PERMIT

SEWAGE DISPOSAL SYSTEM

A REPAIR

SUBDIVISION _____ ROAD 5079 Landing Road LOT 7 1/2-722

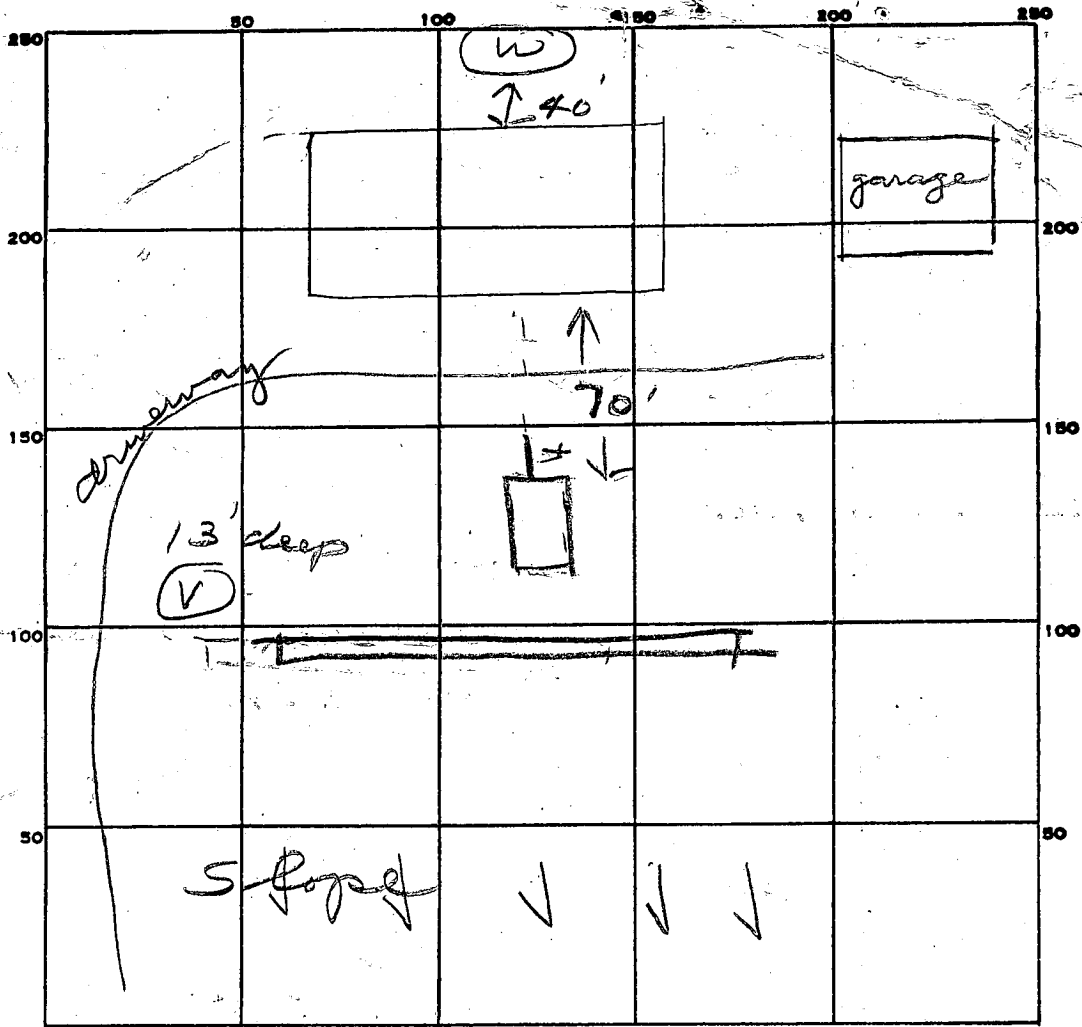
REMARKS 7/17/84 Visual 13' - 2' clay, all mixed clay sand

lyam. Did not perc. 18

7/30/84 ADD STONE & PIPE TO DITCH & CALL OK TO COVER TANK RH

7/31/84 STONE ADDED
